Interactive comment on “Determinants of thermal regime influence of small dams” by André Chandesris et al.

André Chandesris et al.

Received and published: 15 July 2019

Fig. 1. Figure 7. PCA analysis. Correlation circle with temperature as active variables

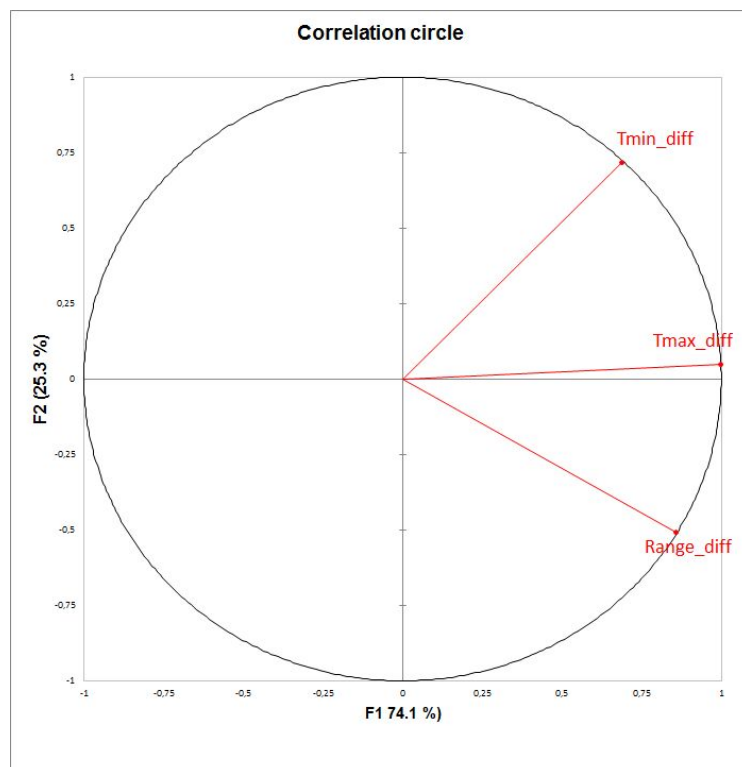
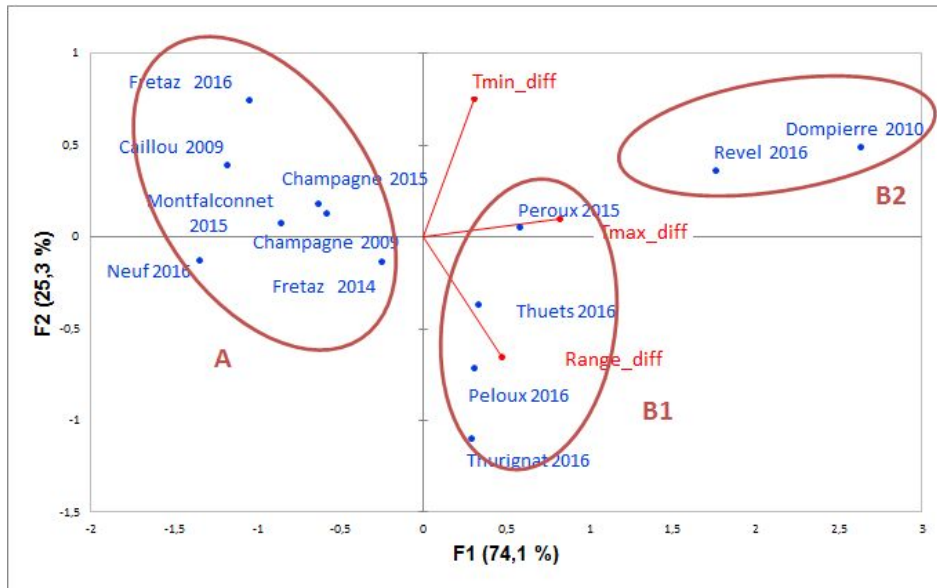
"Section 2.5: Please elaborate further on how you performed your PCA. Illustrative variables are explanatory variables? "In order to identify characterization of the impacts of the different dams" – reformulate, unclear!"

2.5 Ordination analysis To characterize the impacts of the different dams, a principal component analysis (PCA) was carried out using the software XLStat (ADDINSOFT™) on the three water temperature variables: downstream/upstream difference of the maximum and minimum daily temperature and daily temperature range. We used the median values for variables on each time-series in order to build an input matrix (13 occurrences for three variables). Then a complementary redundancy analysis (RDA) with automatic stepwise variable selection procedure was used to identify the physical dam characteristics (Table 1) that significantly explain the PCA results (ter Braak 1986). After the RDA identified the relevant physical dam characteristics, we conducted multiple linear regression between these characteristics and temperature variables to determine specific effect sizes of these characteristics on thermal regime. Ter Braak, C. J. F.: Canonical correspondence analysis: a new eigenvector technique for multivariate direct gradient analysis, *Ecology*, 67, 1167-1179, 1986.

3.6 Ordination results The first axis of the PCA analysis (74.1% of total inertia) is correlated to all temperature daily variables (calculated as differences between downstream versus upstream), in particular to the maximum daily temperature difference (Tmax_diff). The second axis (25.3%) discriminates the daily amplitude difference (Range_diff) with the minimum temperature difference (Tmin_diff) (Fig. 7). Results of the RDA show that the water residence time and the impoundment surface explain 95.2% of the PCA structure (time series plotted on the first and second axis). The projection of the site series on these axes shows a strong spreading along the first axis. The dams that had two different measurement years stay within the same range on this first axis (i.e., Fretaz and Champagne) (Fig. 8).

Fig. 3. Figure 2. Time-series of water temperature (°C) upstream (blue) and downstream (red) of the dam Fretaz, Veyle stream, respectively in years 2014 and 2016.

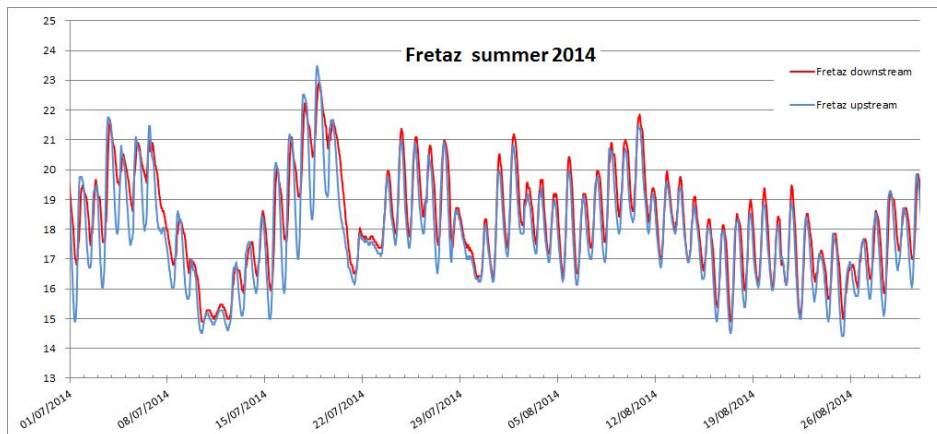
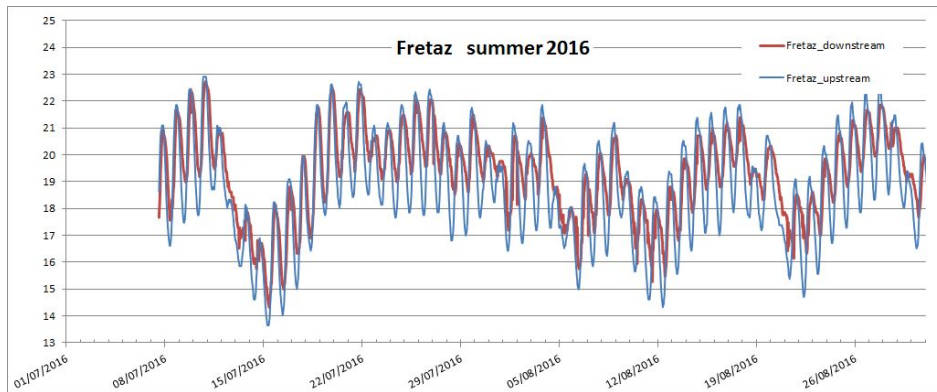
"Section 3.2/Fig. 4: I understand that the scatter plot for Dompierre shows "type 2", so like in Figure 3. However, Neuf in Fig. 4 does not show "type 1", like in Figure 2, because there is almost no difference between minimum temperatures up- and downstream. And, why don't you simply show the same data in your timeseries plots (Fig. 2 and 3) and the scatterplot (Fig. 4) to illustrate the two types. Also, better to combine the figures and make the two types more clear by that."

Response: We follow the recommendation and propose a new set of figures

Fig. 2 Fretaz 2014 and 2016 and Fig. 4 Dompierre (type 2) and Fretaz (type 1)

Fig. 7. Figure 10. Mean of the daily maximum duration with T above 22 °C , upstream and downstream each site monitored in the study. A (circles), B1 (triangles), B2 (rhombus) are the groups of sites resulting

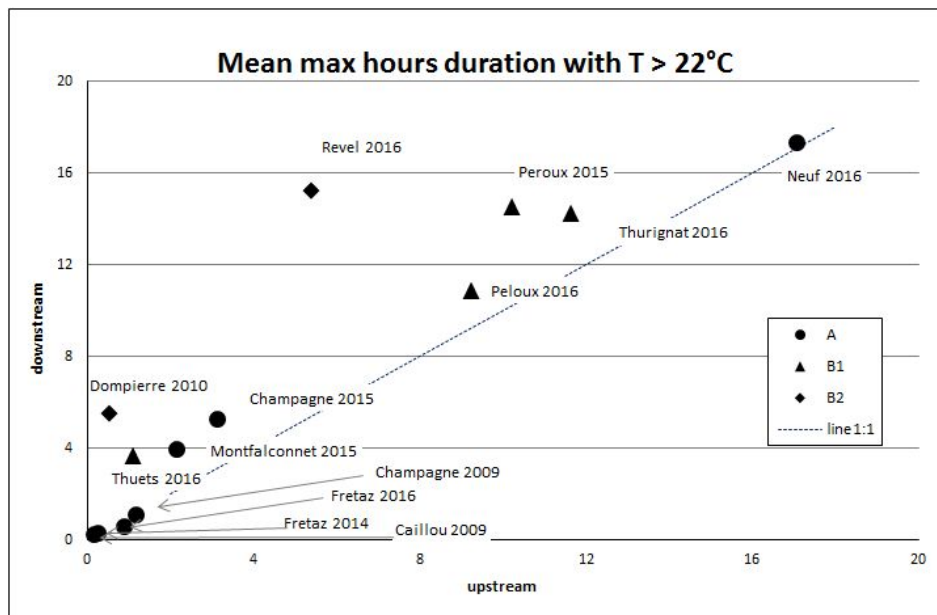
"Section 3.7: Confusing to speak of "short period of time" or "three consecutive days" – what you actually do is to look at shifts in intra-daily temperature variation."

A new sentence is added in 2.4 data analysis To assess the potential biological importance of dam thermal effects, we also calculated 1) the number of days that water temperatures were greater than 22°C, and 2) the mean of the maximum daily duration (in hours) where water temperature was greater than 22°C. We chose 22°C as an illustrative threshold known to be a thermal stress benchmark value for salmonids (Elliott and Elliot, 2010; Ojanguren et al., 2001).

4. calculation of the number of days above the biological 22°C threshold, and 5. calculation of the average maximum daily duration (in hours) above the biological 22°C threshold.

We add a new figure (Fig.10) "Section 4, first paragraph: Some of this would be better
